Best Buy Premium Design Center

Conversion

MAVD TO MDC (PDC)

Plan outline for converting MAVD electronics to MDC (aka PDC) configuration

827-046-1
SPEAKERS 41-48B
SPEAKERS 73-86B

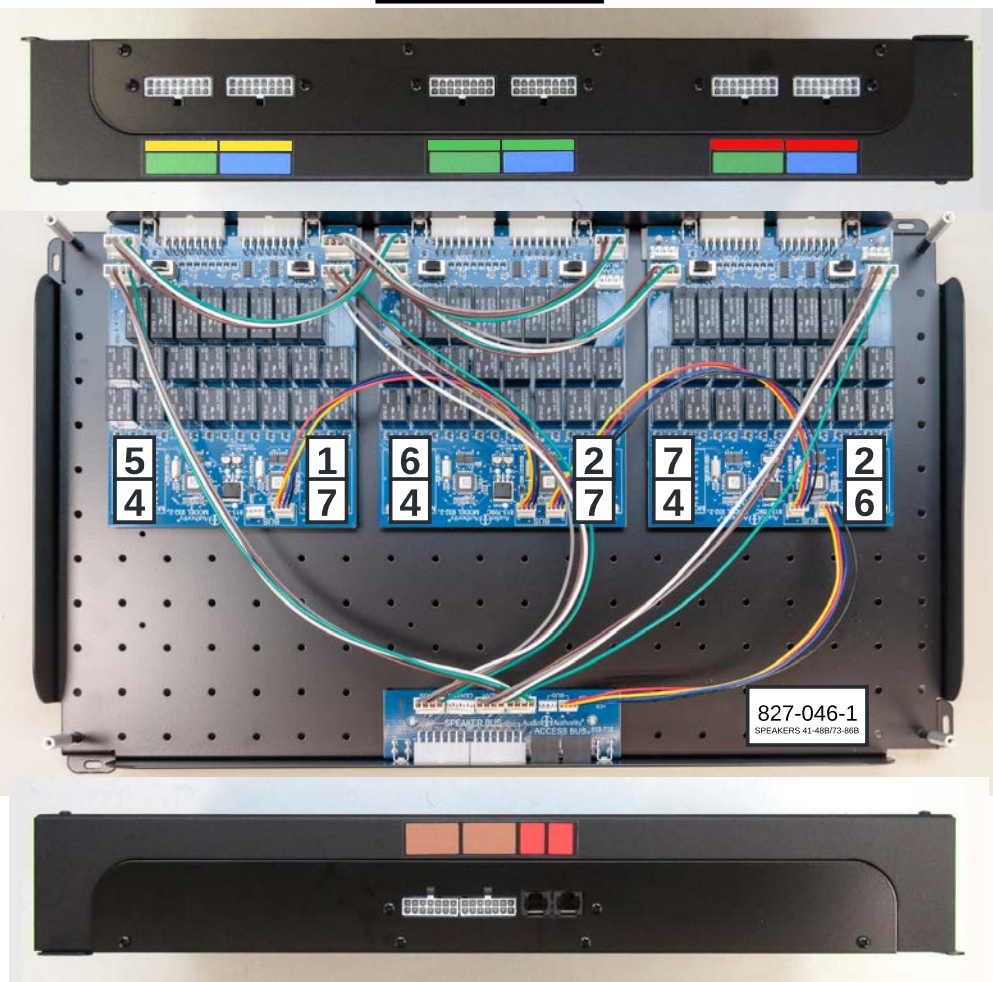
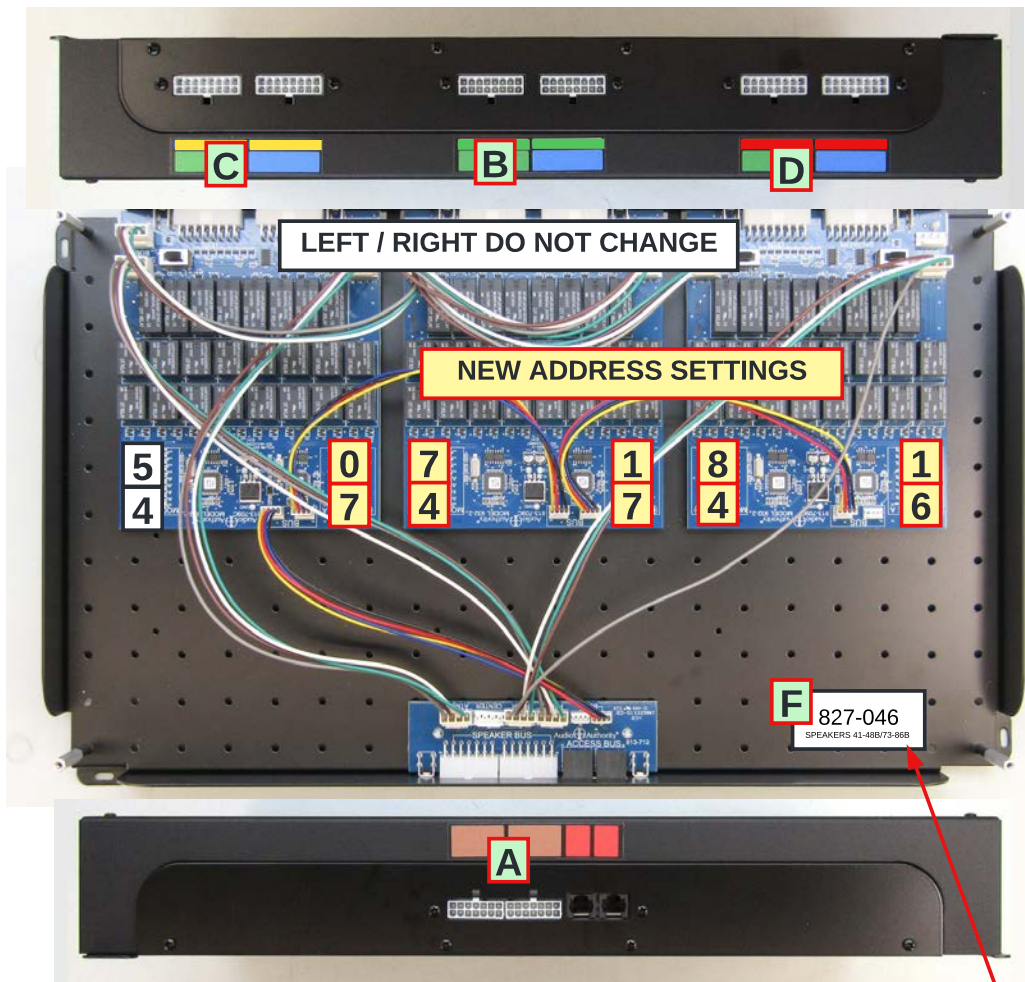
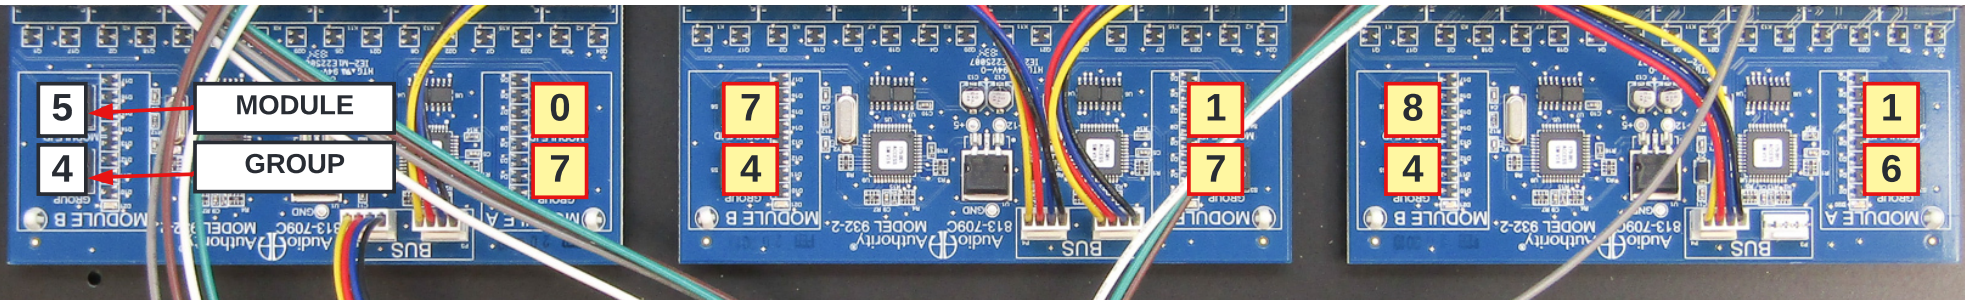
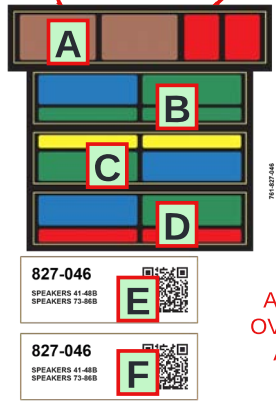
NEW ADDRESS SETTINGS

REPLACE LABELS A-D
ONLY IF MISSING OR
DAMAGED

APPLY NUMBER
OVERLAYS INSIDE
AND OUTSIDE

APPLY WIREMAP
OVERLAY INSIDE LID

HOW TO CHANGE 827-046-1
TO 827-046 (SPEAKERS 41-48B/73-86B)
REPLACE OVERLAYS AND **CHANGE ADDRESSES** AS NOTED
